Subject: VIRGIL C. SUMMER NUCLEAR STATION (VCSNS) UNIT 1  
DOCKET NO. 50-395  
OPERATING LICENSE NO. NPF-12  
SOUTH CAROLINA ELECTRIC & GAS (SCE&G) RESPONSE TO  
REQUEST FOR ADDITIONAL INFORMATION  
LICENSE AMENDMENT REQUEST - LAR 10-03912  
TECHNICAL SPECIFICATION CHANGE REQUEST FOR TS 3.5.4,  
REFUELING WATER STORAGE TANK (RWST)

**VIRGIL C. SUMMER NUCLEAR STATION (VCSNS) Unit 1  
DOCKET NO. 50-395  
OPERATING LICENSE NO. NPF-12**

**SCE&G's Submitted Additional Information**

### **Evaluation of Current Leakage to 20" RWST Header**

Figure 2

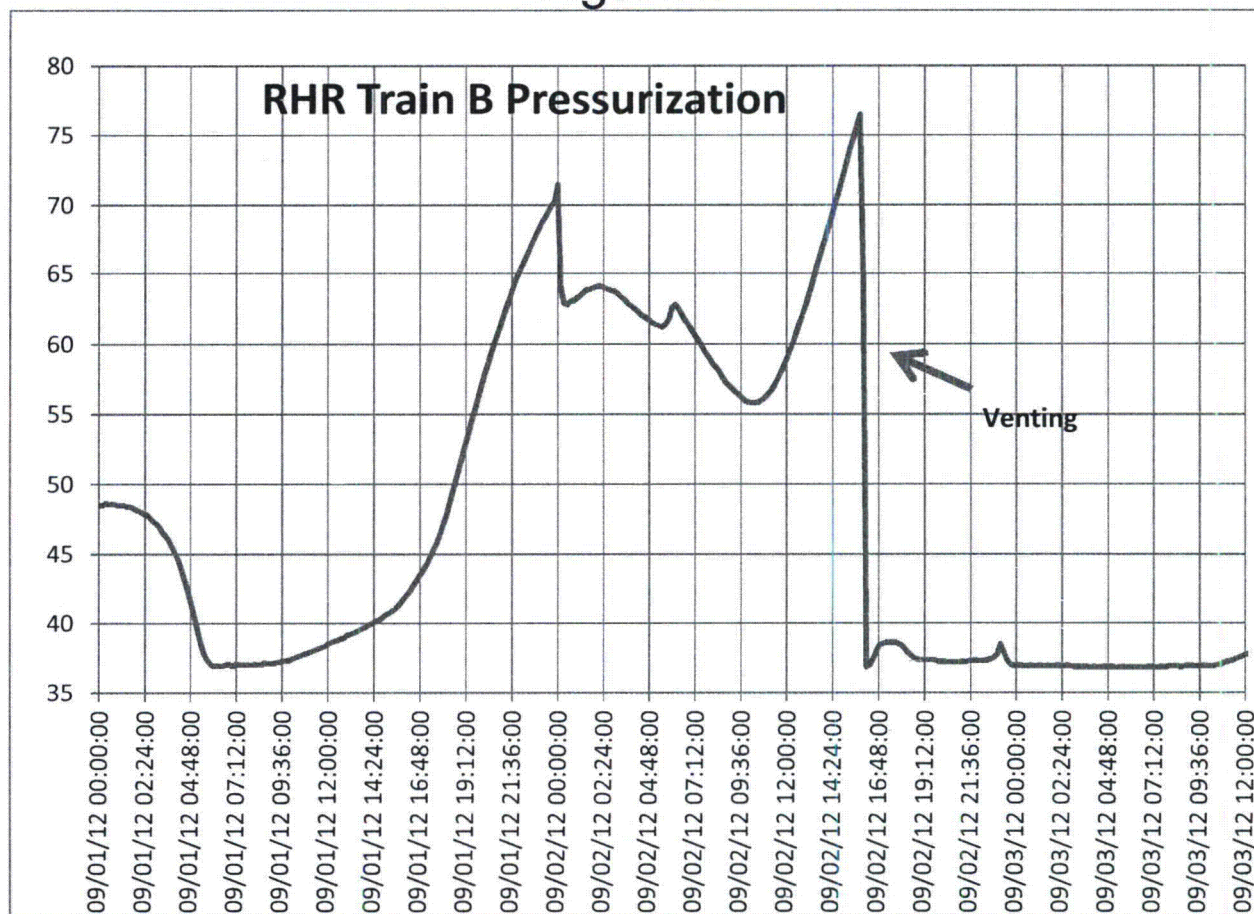
RHR Train B has in the last cycle experience a recurrent pressurization. Activities to reduce air intrusion have resulted in the loop being water solid. It is currently theorized that ambient temperature changes are causing the pressurization. A plot of RHR pressure for a recent occurrence is provided in Figure 2.

Regardless of the cause, the RHR loop B is being pressurized. The only way this could happen is if the associated check valve (XVC08958B) is leak tight. The RWST head normally pressurizes the RHR suction pipe to about 35 psig. At 70 psig, the differential pressure is 35 psid. This is consistent with the expected pressure differentials during post-LOCA operation, thus leading to the conclusion leakage during recirculation is zero.
